Re: Concept Development Application - DA/812/2021 (PPSSCC-285)
33-43 Marion Street, Parramatta
Determination Meeting – 19 May 2022

Response to Issues – Concept Development Application – DA/812/2021
33-43 Marion Street, Parramatta

DRAWING
LEVEL 5 LANDSCAPE PLAN

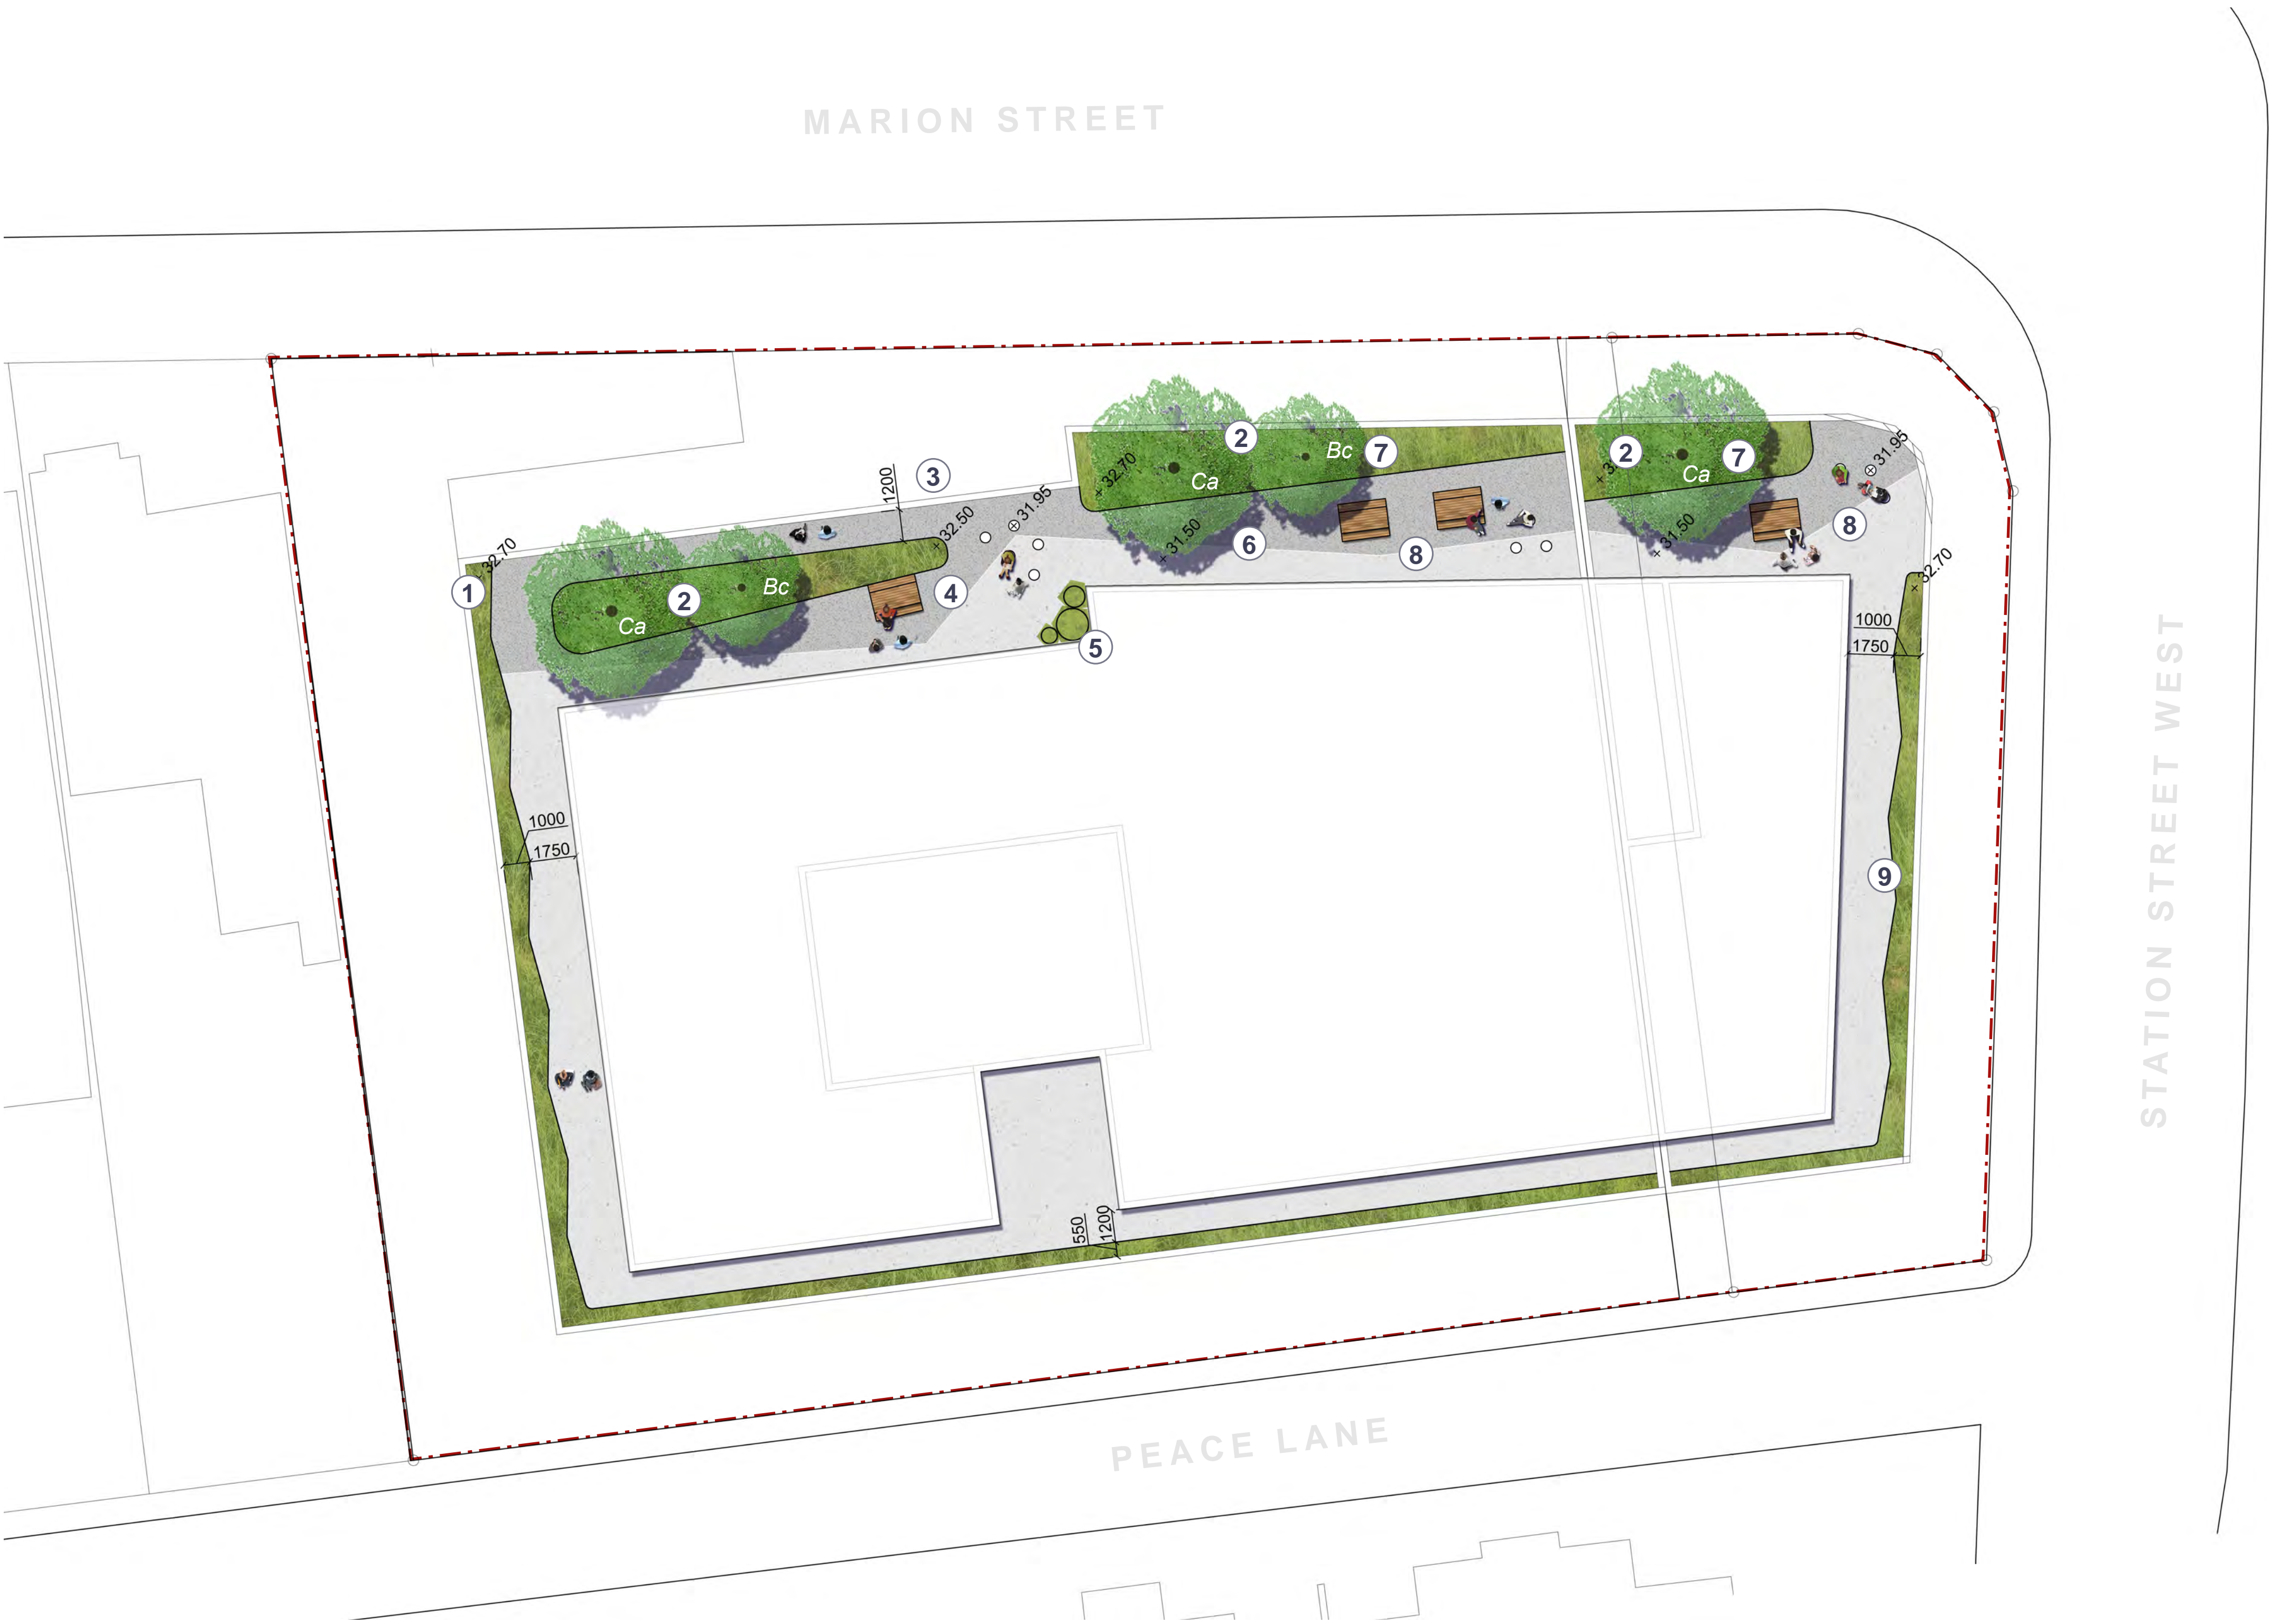
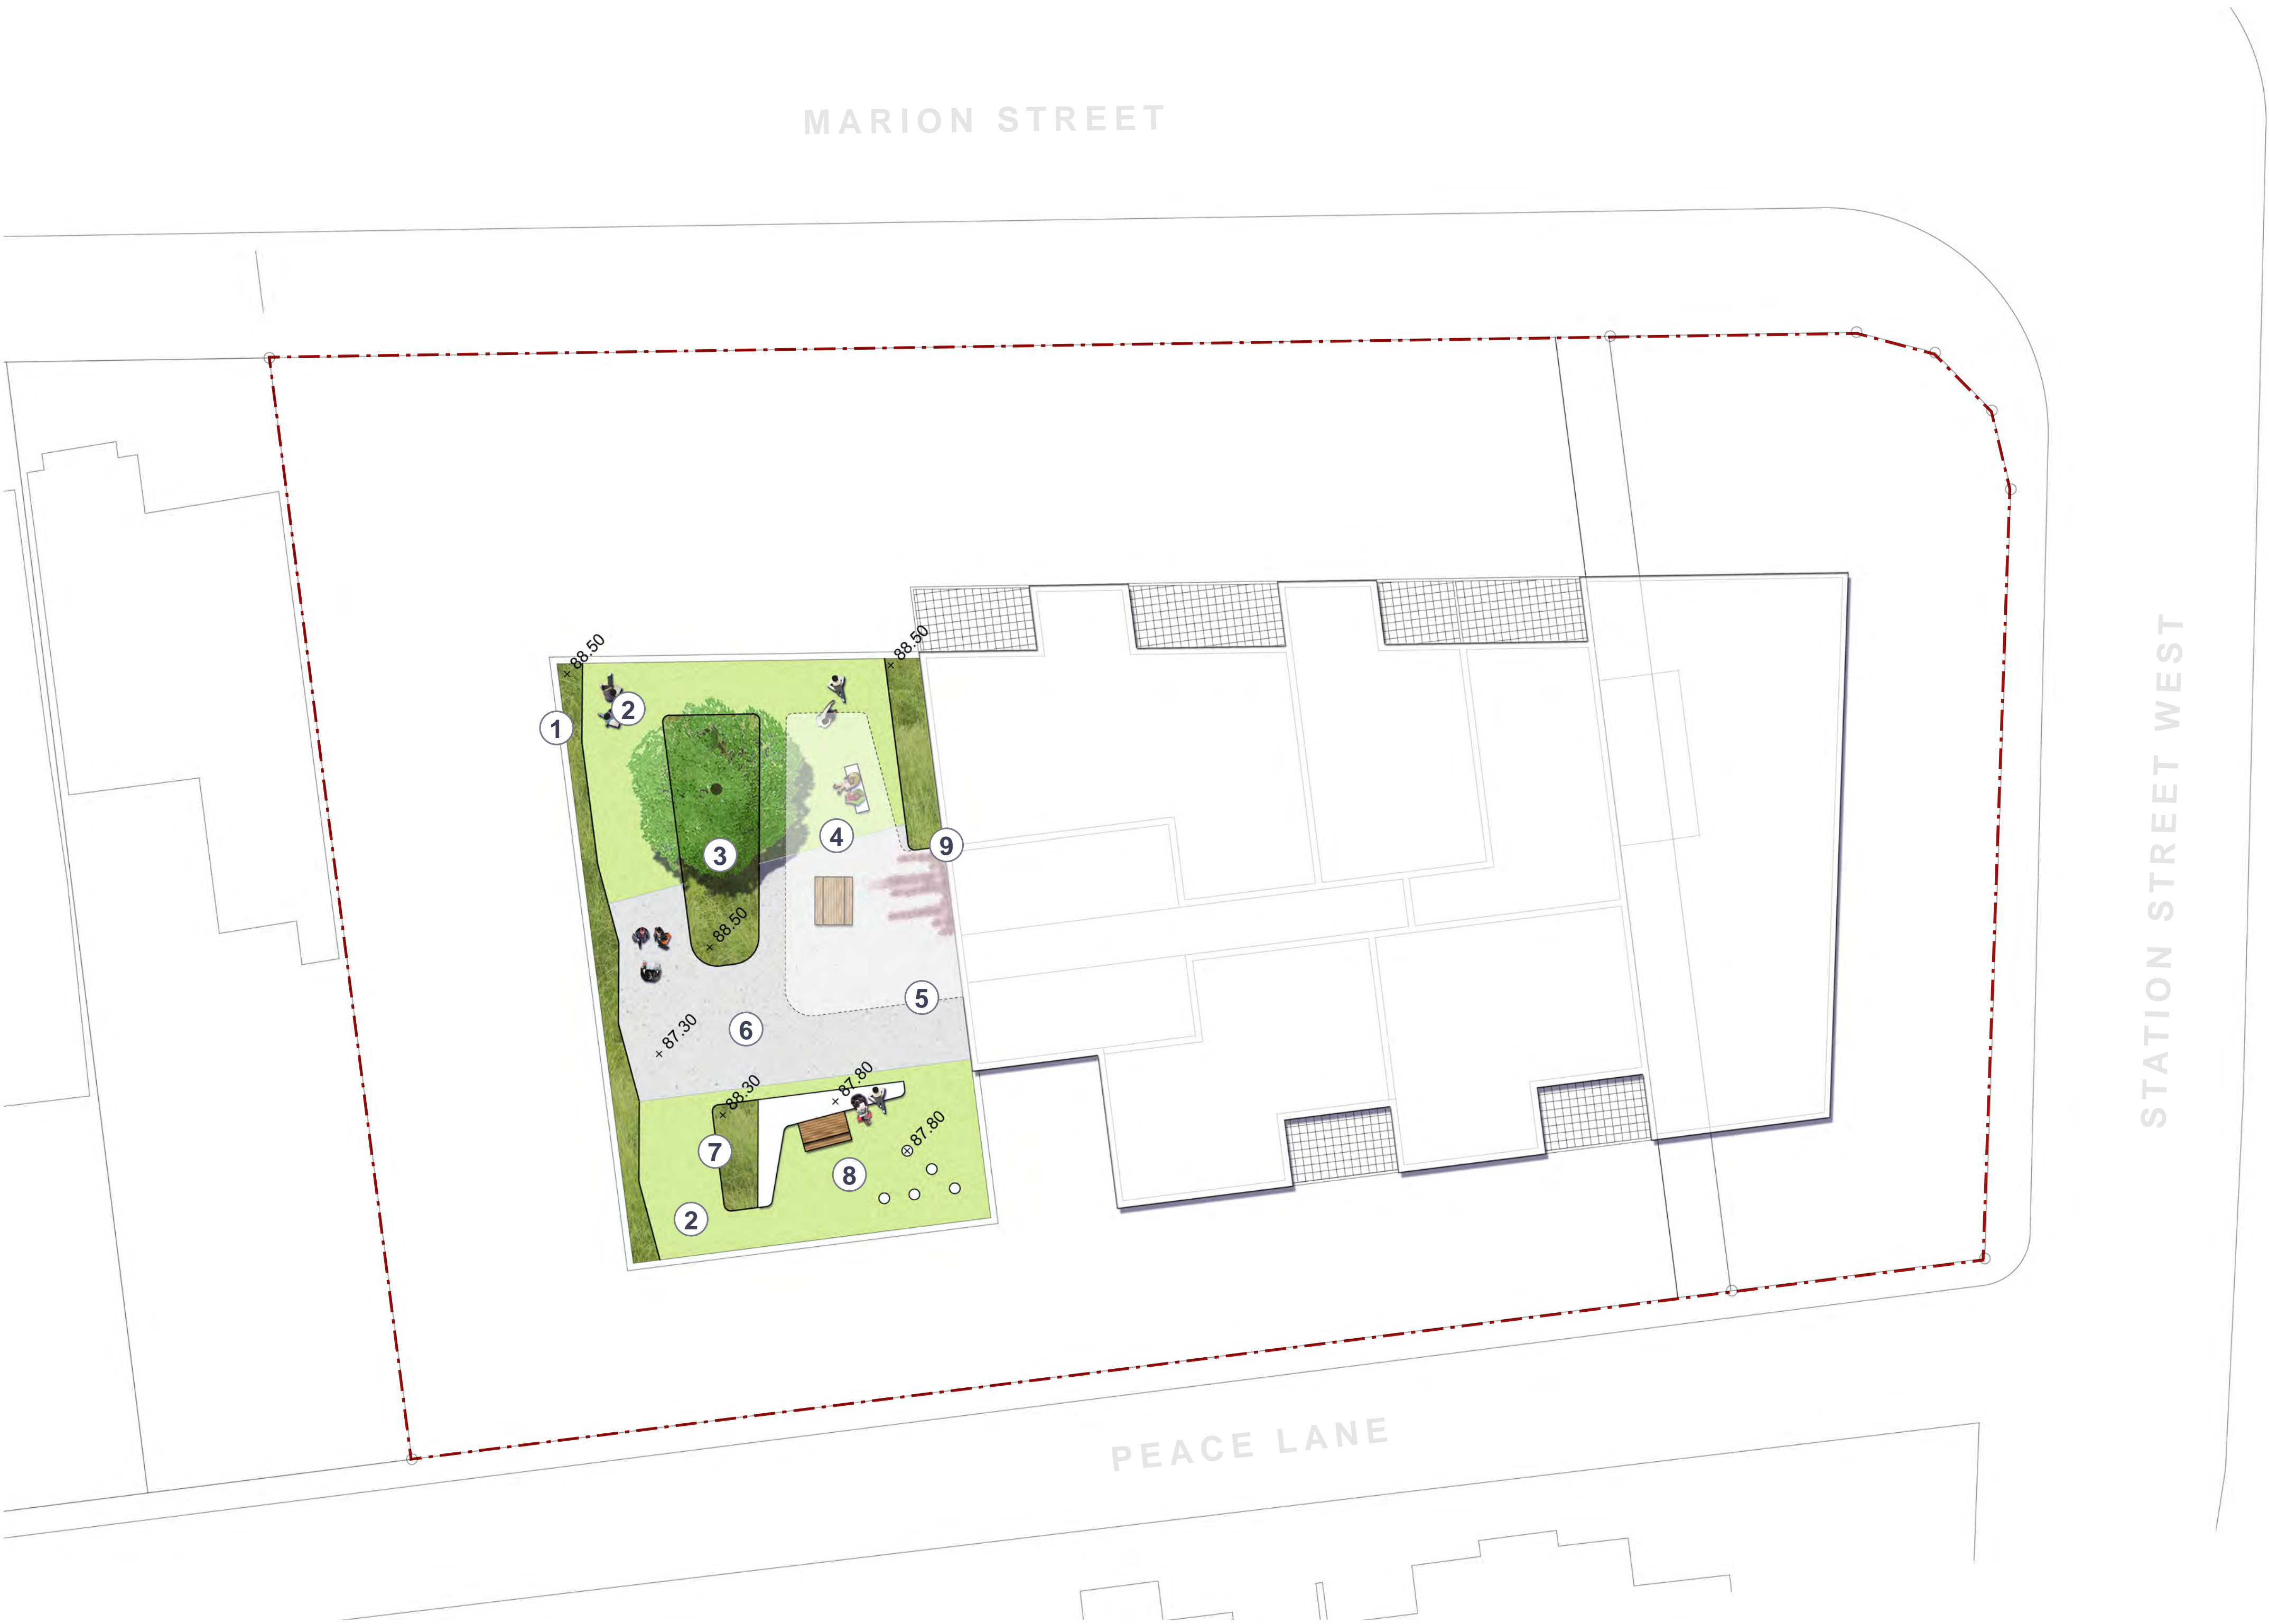
The proposal does not provide the required communal open space for residential units. Approximately 15% of site area provided.

- 1. Non climable planter with planting to total 2m high (including planter) to provide screening to neighbouring property
- 2. Feature trees with understorey planting to raised island planter. Minimum soil volume provided for small tree 15m3 as per the Apartment Design Guide.
- 3. Views directed to the North
- 4. Picnic table to island planter
- 5. Planting to feature pots
- 6. Two tone paving
- 7. Non climable planter
- 8. Picnic tables
- 9. Non climable planter with planting to 2m high (including planter) to provide screening from railway
